PZ&B Staff Combination Memorandum: Landmarks Preservation Commission and Town Council

SUBJECT: COA-24-0022 (ZON-24-0055) 120-132 N COUNTY RD—
Palm Beach Synagogue

MEETING: DECEMBER 18, 2024, LPC
JANUARY 15, 2025, TC

PREVIOUSLY PROPOSED COURTYARD PERSPECTIVE

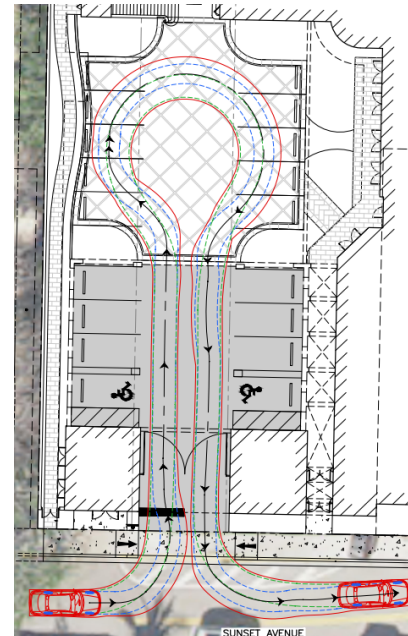
Architecturally, the building's south elevation (Sunset Ave) has not changed. However, the proposed building reduction will impact how the property is experienced internally. The changes to the new addition will not negatively impact the landmarked portions of the building. Furthermore, the architecturally compatible design and use of materials are maintained in the revised proposal.

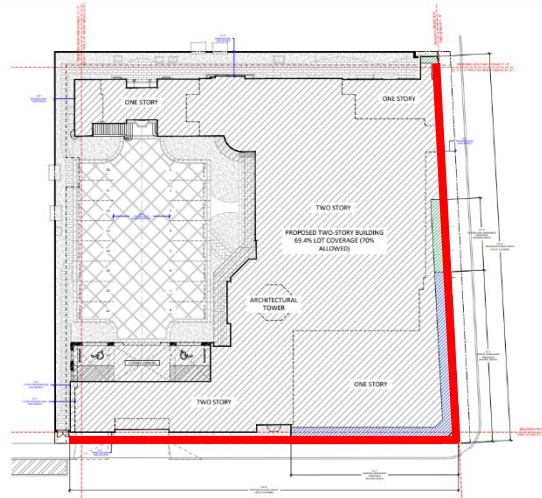
Variance #4 requests to exceed the maximum building length of 150'-0" maximum building length permitted; the request pertains to both sides (east and south) for the proposal of alterations and substantial additions of the corner building of N County Road and Sunset Ave. Along N County Road, the existing landmarked synagogue building has a 76'-2" long frontage plus an additional 32'-2" of non-landmarked portion of the synagogue. The other structures (formerly occupied by Chez Jean-Pierre Bistro) has a 63'-8" long frontage. This structure was approved to be demolished and is proposed to be replaced by an attached new addition. The variance along the east (N County Road) is to exceed the allowance by 22'-0" for a total frontage of 172'-0". This will extend the building nearly the entire linear length (174') of the eastern side of the site which will provide for a continuous urban edge, an optimal urban condition along commercial main streets. For visual reference, the landmarked portion of the proposal is highlighted in blue in the diagram to the right.

As the variance request pertains to the building along the Sunset Ave frontage. The existing building has a building length of 74'-7" and the new additions will extend this by 87'-5" to a total length of 173'-0" along the south (Sunset Ave) of the site. And while this portion of the variance is not a vesting of the existing conditions, it too, creates a continuous architectural edge to the site and will screen the parking in the rear of the site. This elevation will be broken into two portions, by a 7'-0" wide pedestrian accessway that has been provided at the westernmost portion of the site and at the ground floor by a 25'-0" wide covered vehicular driveway also located at the western portion of the site. Overall, the new construction along both elevations of the building have been exceedingly designed to vary in detail, style, features, and changes in plane.

North Elevation

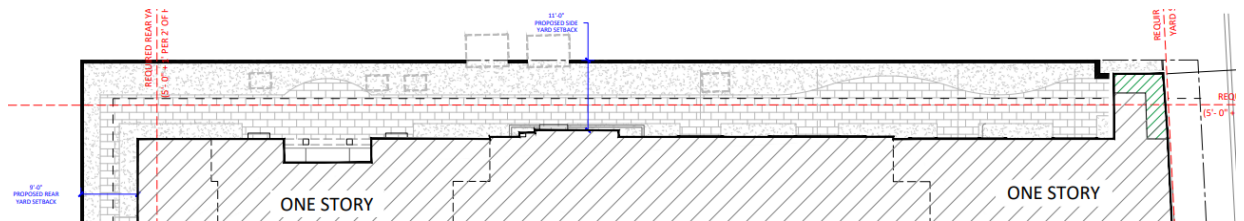
As it pertains to **Variances #8 and #9** to the reduced setback requirement along the two frontages. **Variance #8** to reduce the minimum required side yard (north) setback from 1.8' in lieu of the

required setback of 8'. A portion of the non-landmarked façade on the northeast corner will be preserved. However, due to the overall demolition of the building greater than 50%, the existing setback of 1.8' in this area must be retested. The additions will provide a setback of 11 feet on the north side of the property. Since portions of the addition, exceed a height of 15 feet, an increased from the minimum 5-foot setback is required of one foot for each two feet of building height. Therefore, the variance will only impact the preserved section of the building. Based on building heights, the required setback ranges from 7' to 8'.

West Elevation

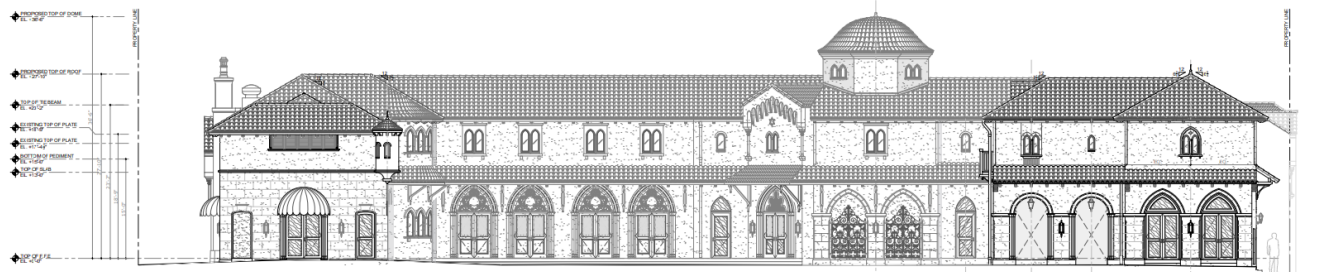
Variance #9 to reduce the minimum required rear yard (west) setback ranging from 7' in lieu of the required setback of 13'. The additions will provide a setback that ranges from 7' to 9'. An increased setback above 15 feet of height also applies to the rear setback areas, however, the minimum setback here is 10 feet. Based on building heights, the required setback ranges from 12.166' to 13'.
